DOCKETED		
Docket Number:	13-AFC-01	
Project Title:	Alamitos Energy Center	
TN #:	202239	
Document Title:	Data Request Set 1	
Description:	Data Requests 1-63	
Filer:	Alicia Campos	
Organization:	CEC/Keith Winstead	
Submitter Role:	Commission Staff	
Submission Date:	4/25/2014 11:27:52 AM	
Docketed Date:	4/25/2014

Regarding: ALAMITOS ENERGY CENTER (13-AFC-01)

DATA REQUEST SET 1 (Nos. 1-63)

Energy Commission Staff's Data Requests Set 1 (Nos. 1-63)

Data Request # 34 Map

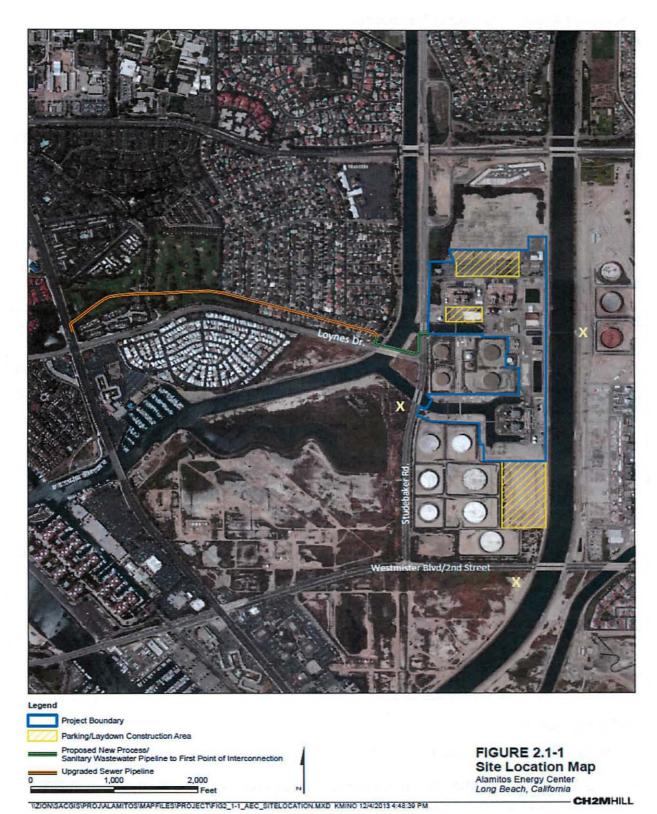
- 33. Please conduct continuous ambient noise monitoring to determine the level of existing noise at important wildlife habitat areas along the San Gabriel River and in the Los Cerritos Wetlands (locations described below and illustrated in the attached map), using the same methods and reporting that were used for the ambient noise survey presented in AFC Section 5.7.3.2. Please provide these data for: (1) the fenceline at the southwest corner of Studebaker Road and Loynes Drive; (2) the fenceline south of East 2nd Street (Westminster Blvd.) and just west of the San Gabriel River crossing, and (3) either bank of the San Gabriel River directly east of existing Unit 4. There is an accessible bicycle path on the east banks of the river. Please contact staff to discuss alternate monitoring locations if for any reason these locations cannot be safely accessed.

- 34. Please provide the anticipated sound level during construction and demolition at the locations where ambient noise monitoring was conducted. Data should be provided in a unit of measure that will allow for a reasonable comparison against the ambient noise data requested under Data Request #34.
